Enclosure 2
Response to NRC Request for Additional Information 339
(Non-Proprietary)

NRC Request for Additional Information

RAI Package 339, Question 399

Figure 1

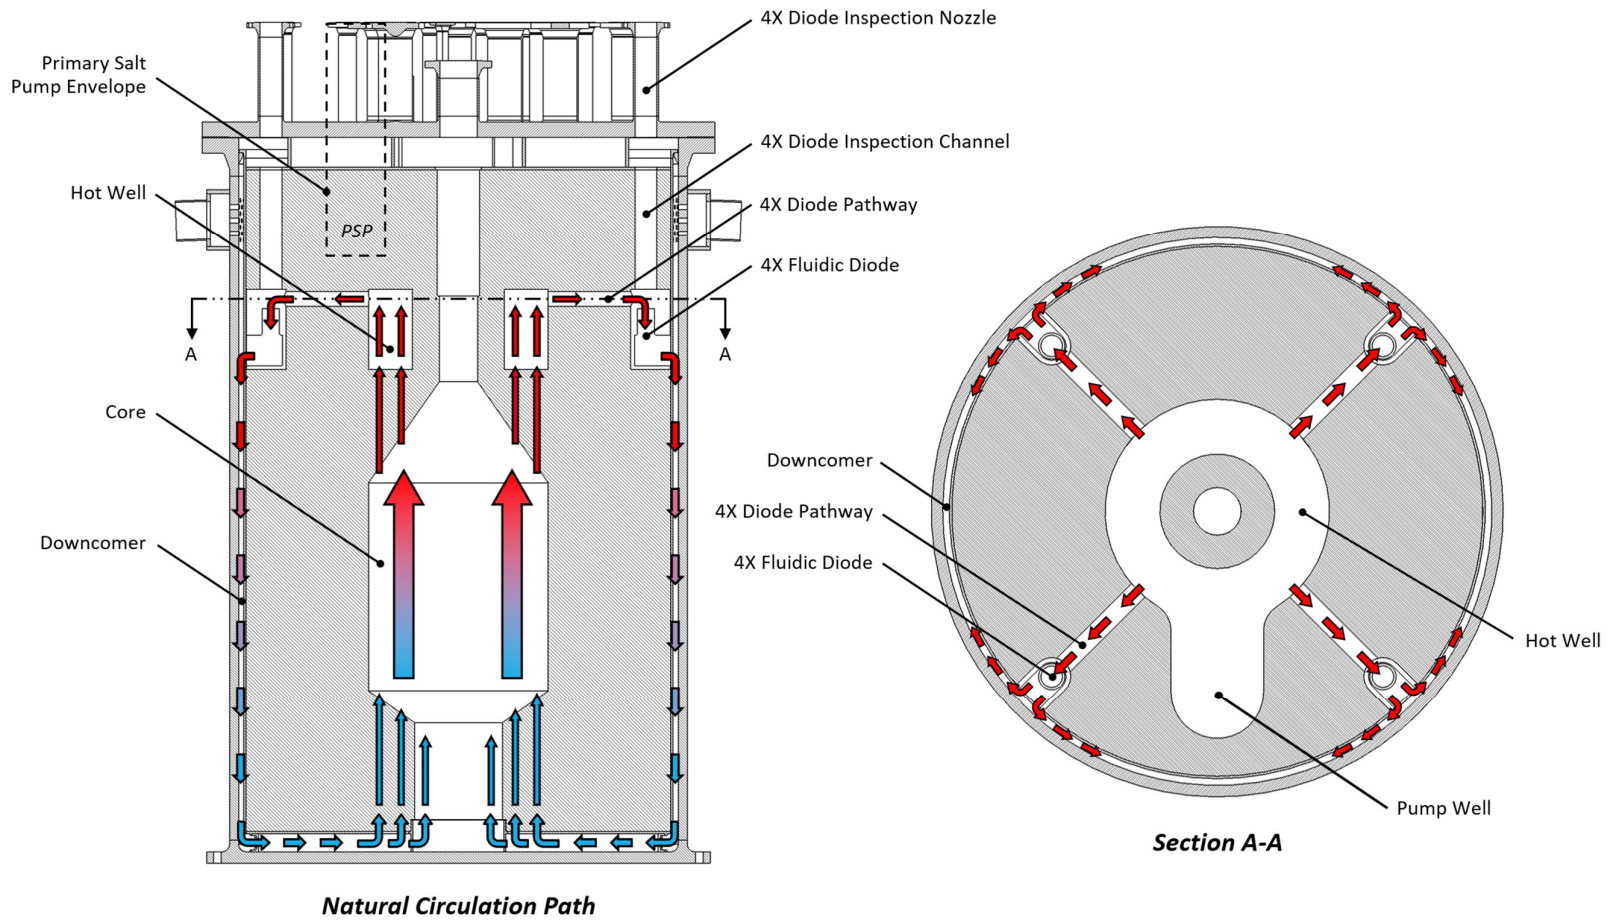
Provide a detail drawing of the natural flow path in the regions above the core.

Figure 1 (provided with this response) shows the natural circulation flow path in the graphite structures above the core.

Figure 4.3-1: The Reactor Vessel System

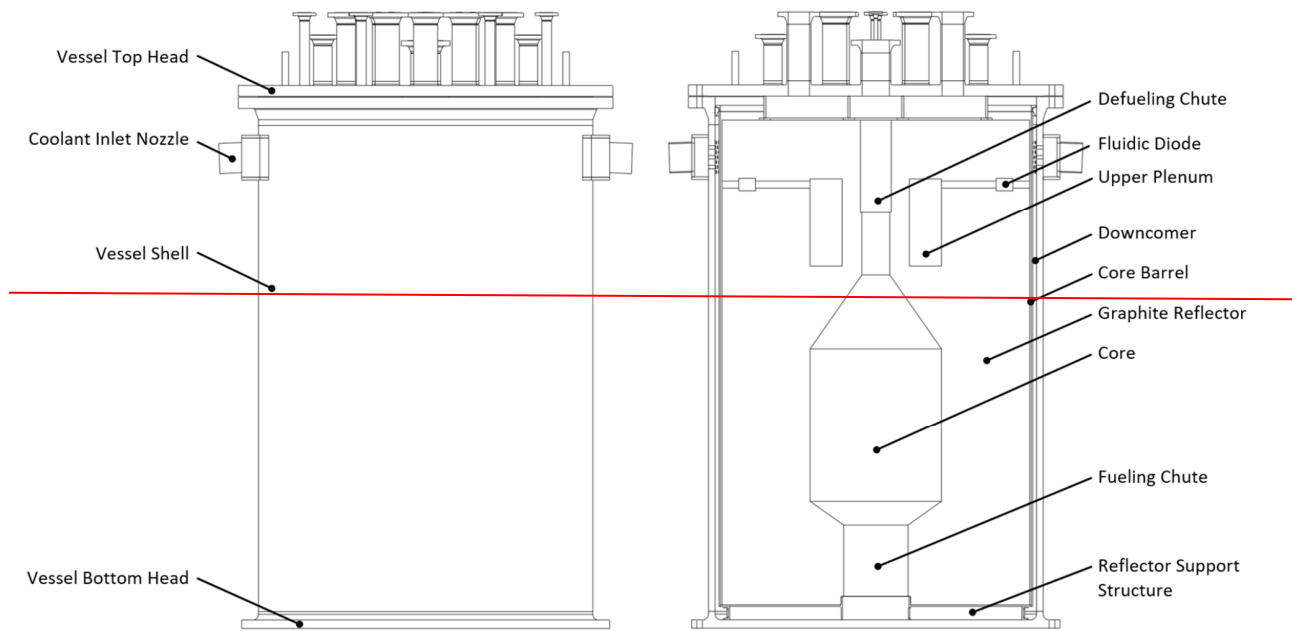
It appears that a potential failure of graphite reflector blocks (e.g., debris, geometry changes, etc.) could cause flow blockages or restrictions of the natural circulation flow path. Where can the flow path be inspected versus where would it need to be verified with flow and temperature monitoring? Can all of the natural circulation flow path that isn't part of forced circulation flow path be inspected?

The downcomer, as described in Section 4.3.1.2.2, is an annular coolant flow pathway between the vessel and the core barrel. Flow from the downcomer moves through the reflector support structure and into the reflector block coolant inlet channels. The graphite reflector block structures are machined to form a physical geometry for reactor coolant to pass through as described in Section 4.3.1.2.1 of the Preliminary Safety Analysis Report (PSAR). The physical geometry created within the graphite structures that form the reactor coolant natural circulation flow path includes the core, coolant channels, annular hot well, and diode pathway. This natural circulation flow path is clarified in Figure 1, as well as the attached changes to PSAR Section 4.3.1.2.1, Section 4.3.3, Figure 4.3-1 and Figure 4.6-1.

The reflector blocks form ~~an upper plenum and a hot well and pathways to each of four~~ fluidic diodes, ~~which The fluidic diodes is-a~~ are stainless-steel passive devices ~~s~~ that connects the ~~upper plenum hot well~~ via the pathway to the top of the downcomer via a penetration in the core barrel as shown in Figure 4.3-1. The diode introduces a higher flow resistance in one direction, while having a lower flow resistance in the other direction. The diode restricts flow from the higher-pressure downcomer into the ~~upper plenum hot well~~ during normal plant operating conditions with forced (pumped) circulation. During natural circulation, ~~t~~The flow passes in the low-resistance direction of the diode from the ~~upper plenum hot well~~ to the top of the downcomer ~~driven by natural circulation~~. Nozzles on the reactor vessel head and diode inspection channels in the upper reflector block structure are used to perform remote visual inspections of the fluidic diodes.
